# GUARD RAIL TO BRIDGE RAIL TRANSITION

Vermont Agency of Transportation
RECEIVED
Clarendon BRO 1443(44) Approach Rail Submittal 3-10-16 3-22-2016.pdf

RESUBMIT Yes Rejected

SPECIAL PROVISION, GRAS - CONCRETE COMBINATION BR.
ROUTE NO. T.H. 3 (CLASS 2), RURAL COLLECTOR, BRIDGE # 11
TOWN OF CLARENDON, RUTAND COUNTY, VT.

SHEET 1 OF 12

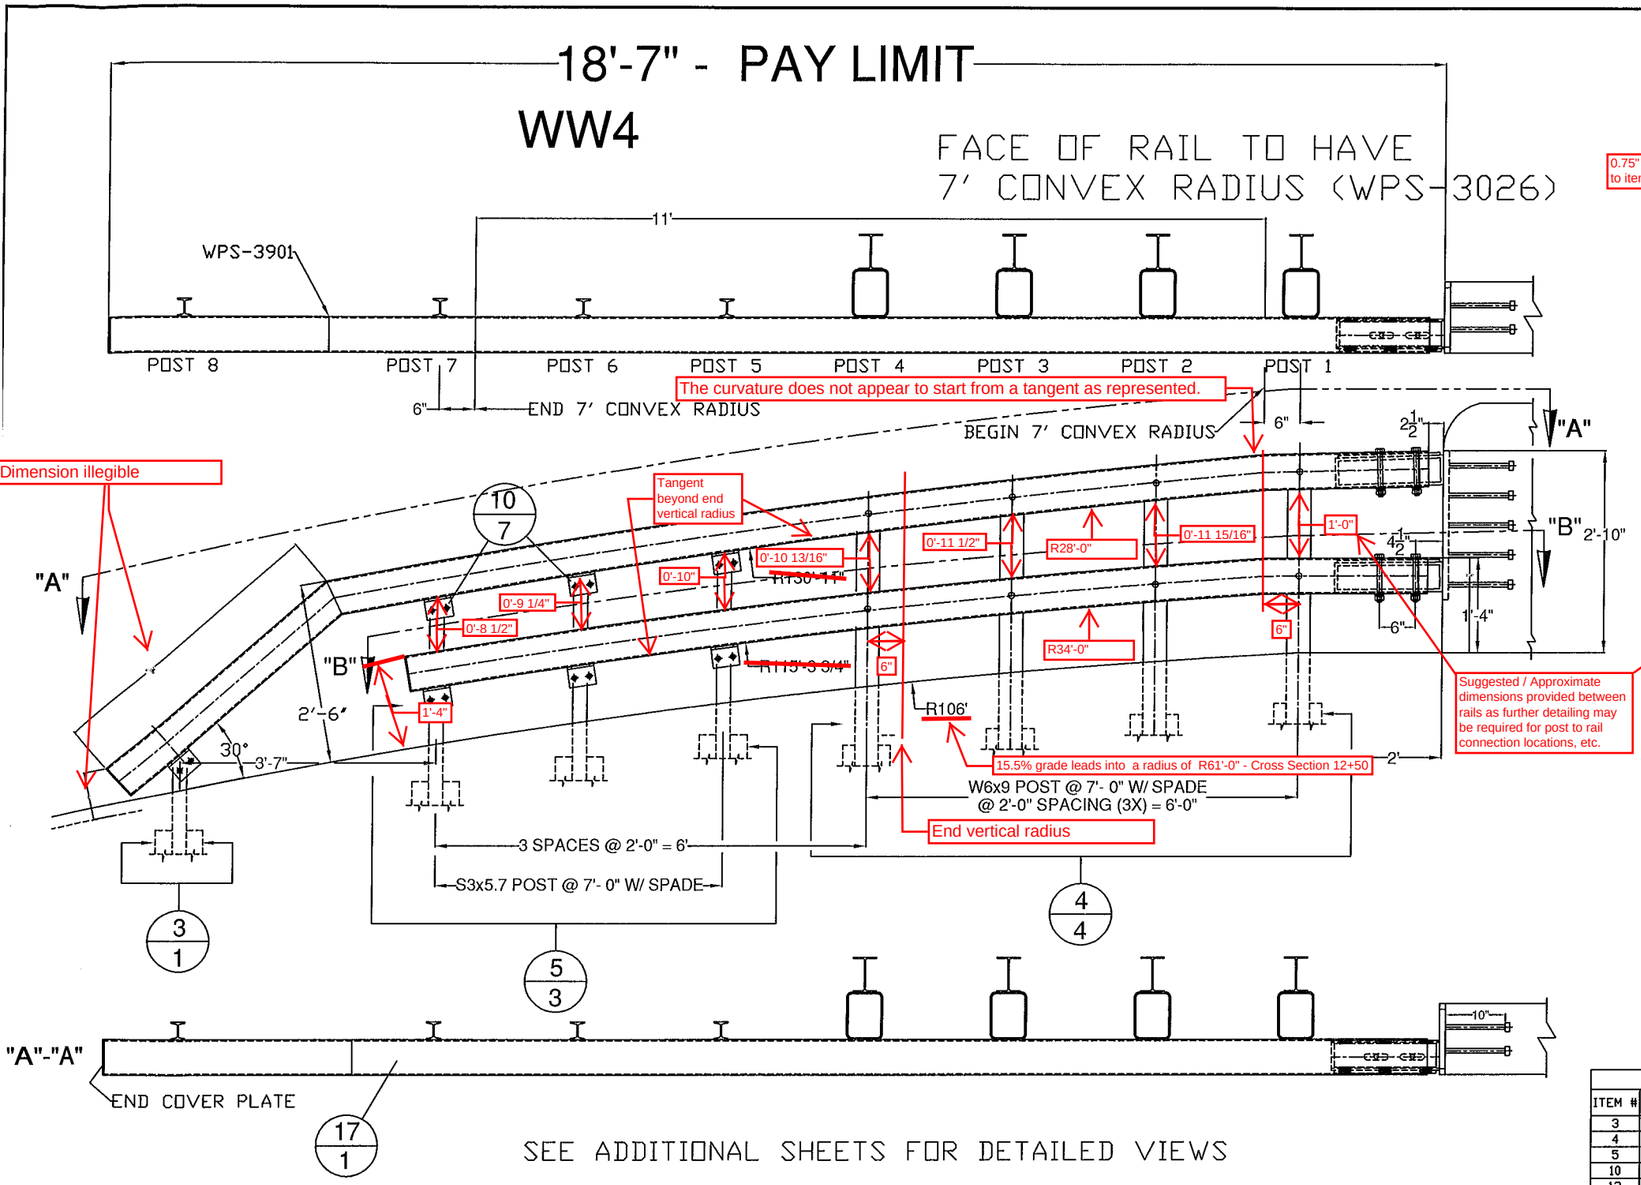
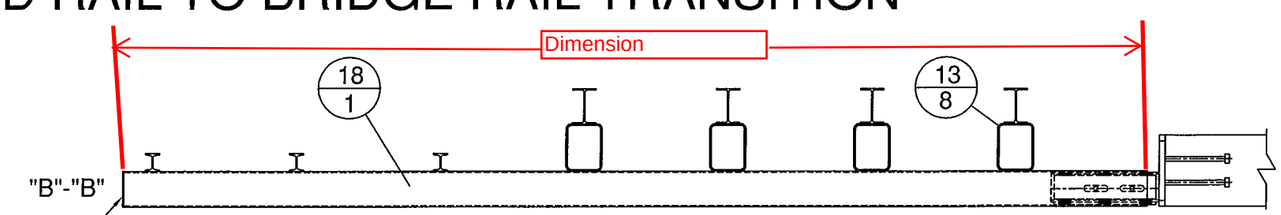
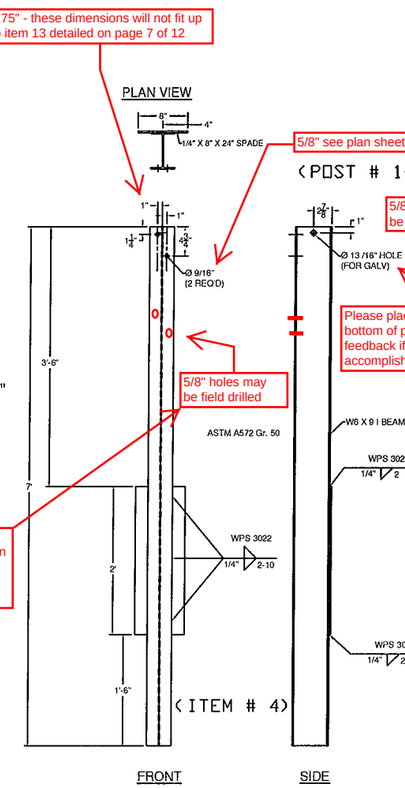
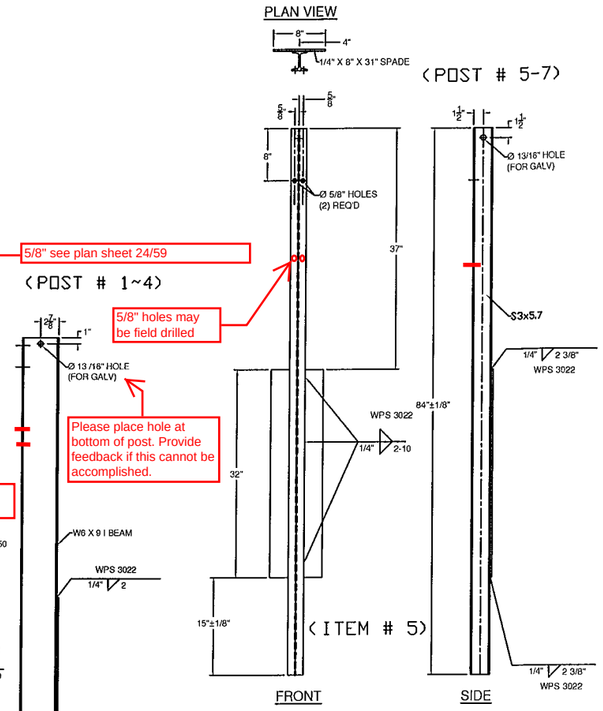
The WPS needs to be called out for the end plates. (TYP)

Provide end cover plate detail. It has not been included in this set of drawings.

SHEET 2 OF 12

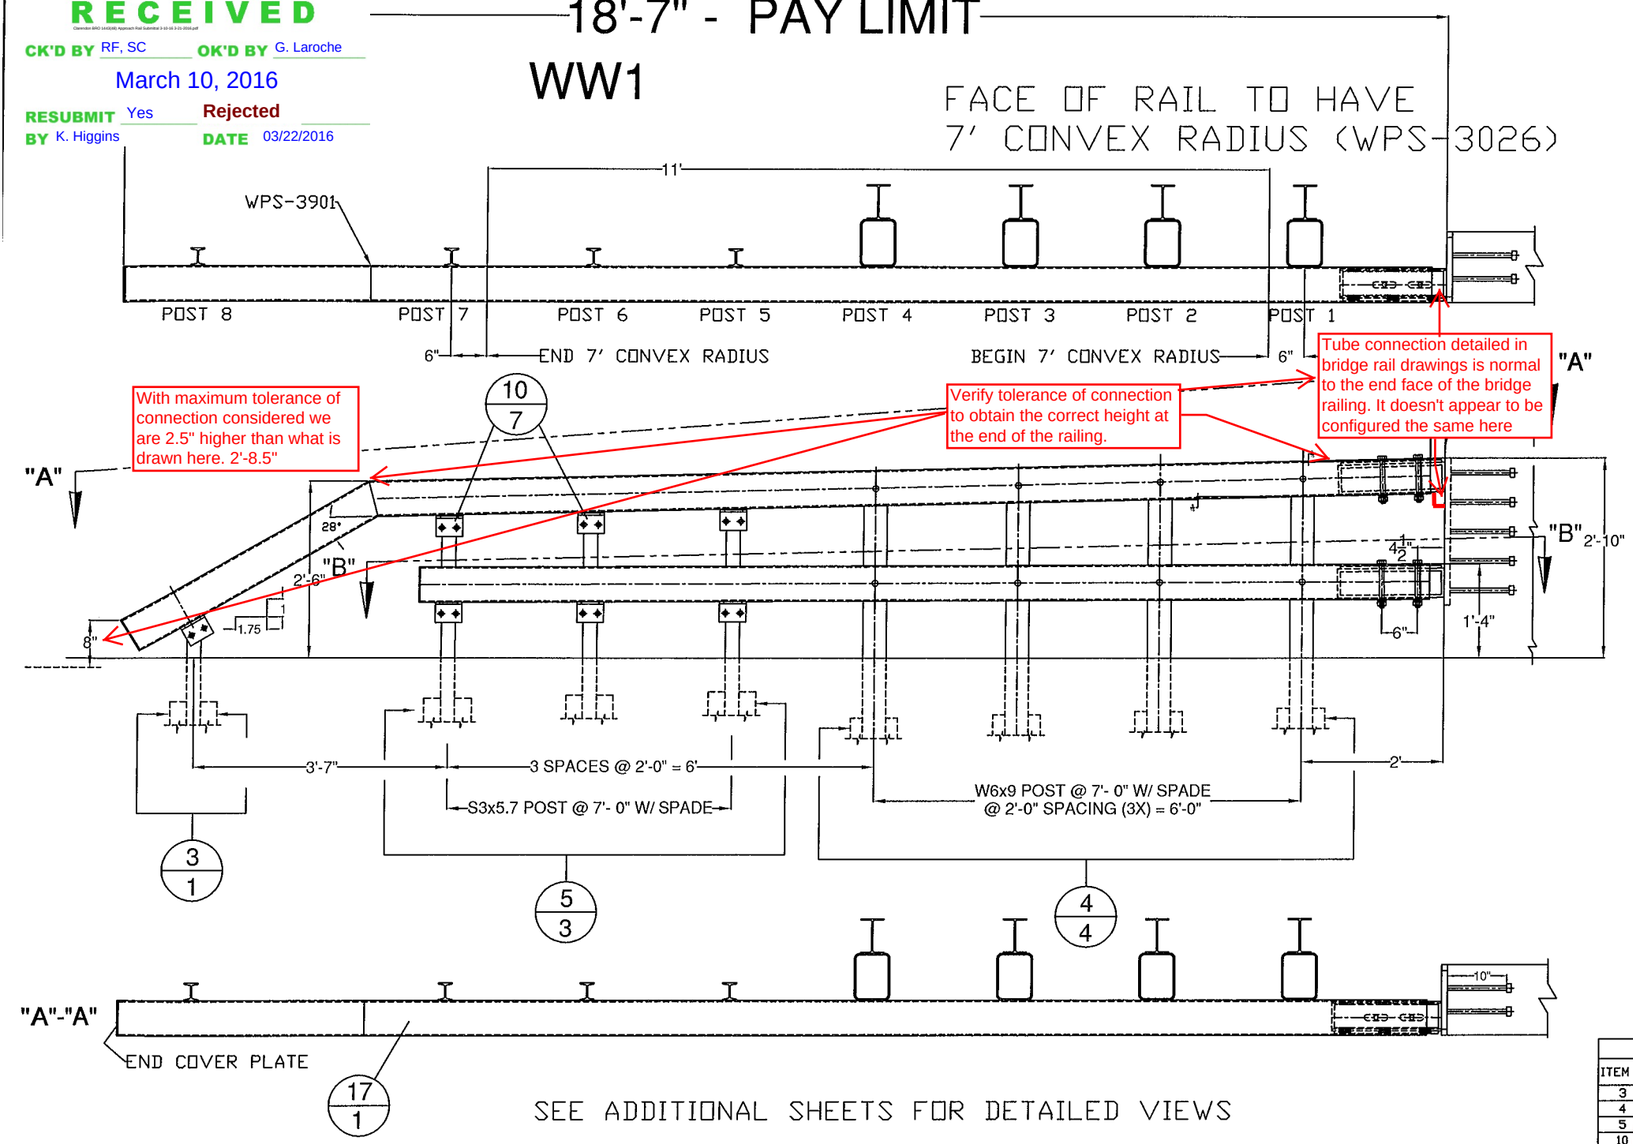
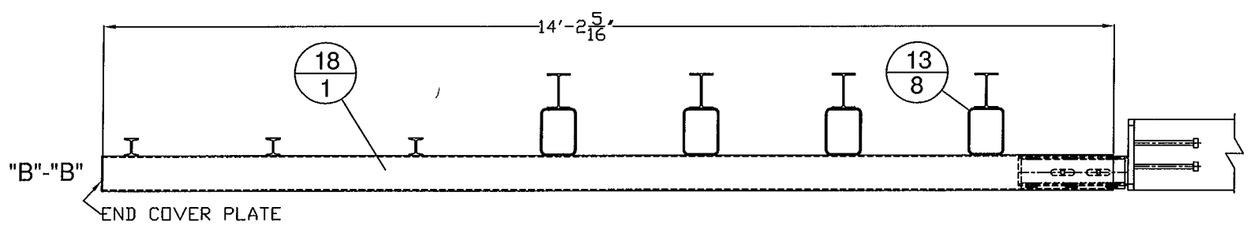
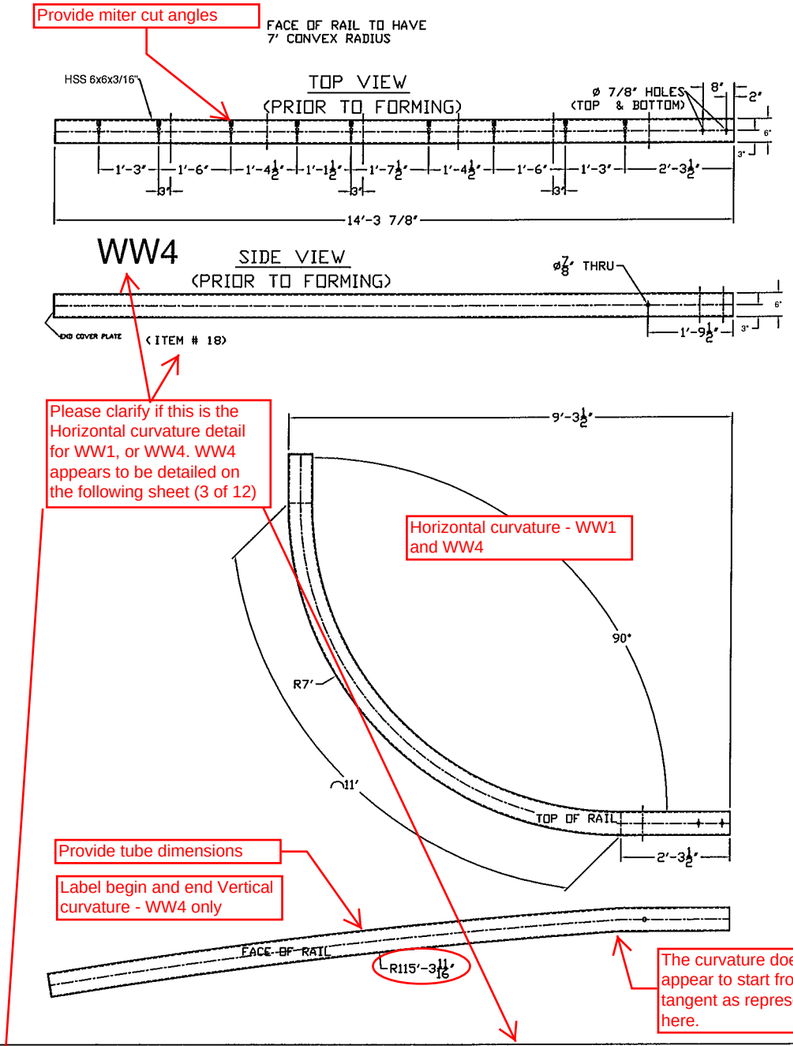
With maximum tolerance of connection considered we are 2.5" higher than what is drawn here. 2'-8.5"

Verify tolerance of connection to obtain the correct height at the end of the railing.

Tube connection detailed in bridge rail drawings is normal to the end face of the bridge railing. It doesn't appear to be configured the same here

The WPS needs to be called out for the end plates. (TYP)

Provide miter cut angles

Please clarify if this is the Horizontal curvature detail for WW1, or WW4. WW4 appears to be detailed on the following sheet (3 of 12)

Provide tube dimensions

Label begin and end Vertical curvature - WW4 only

The curvature does not appear to start from a tangent as represented here.

SHEET 3 OF 12

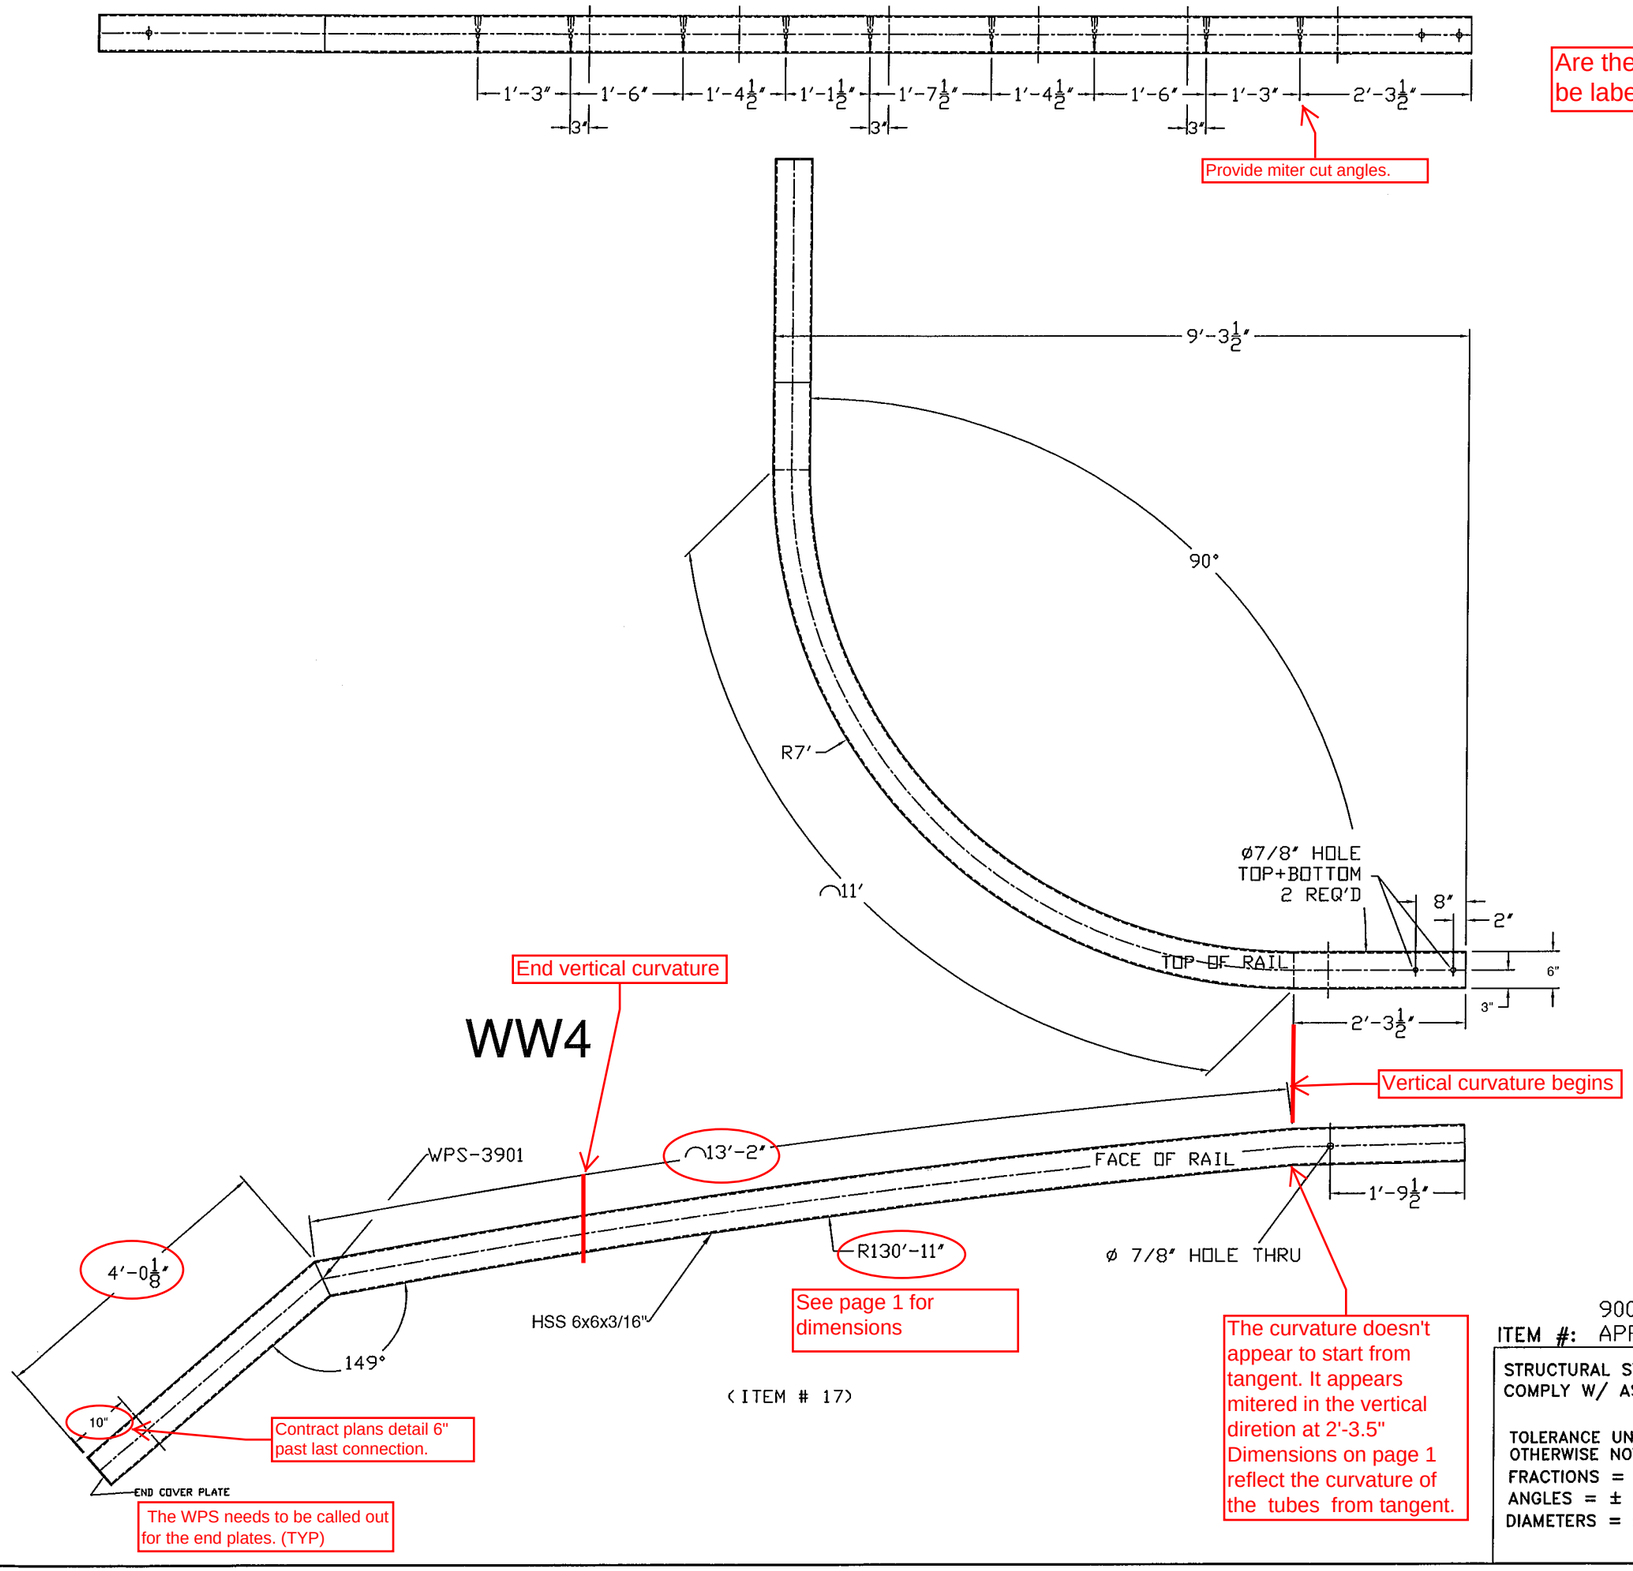
Are these pie cuts with welding? If so, this should be labeled and specify the WPS.

(ITEM # 7)

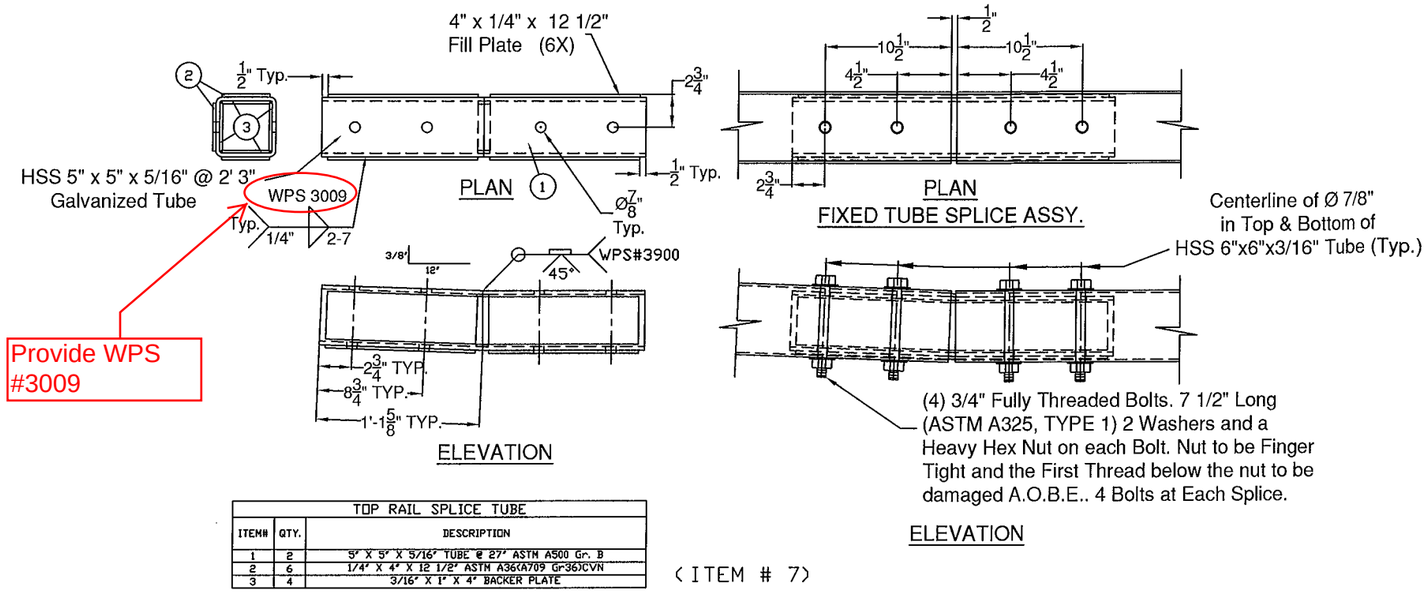
Provide WPS #3009

Provide WPS #3016

(ITEM # 12)

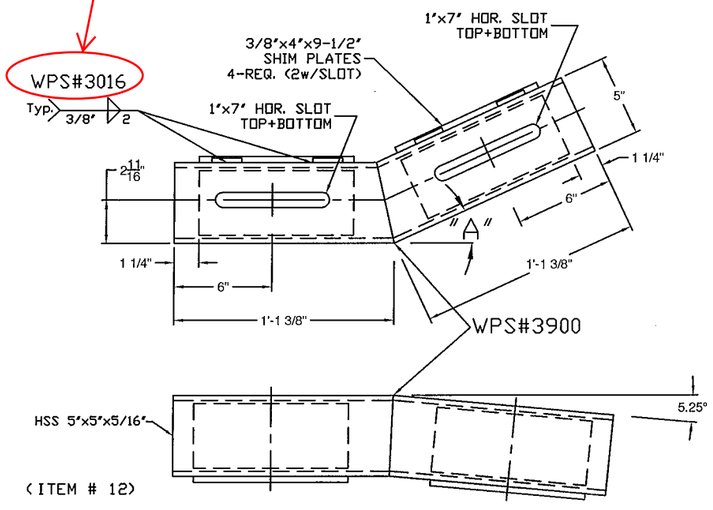
Does not fit up to post hole dimensions on page 1
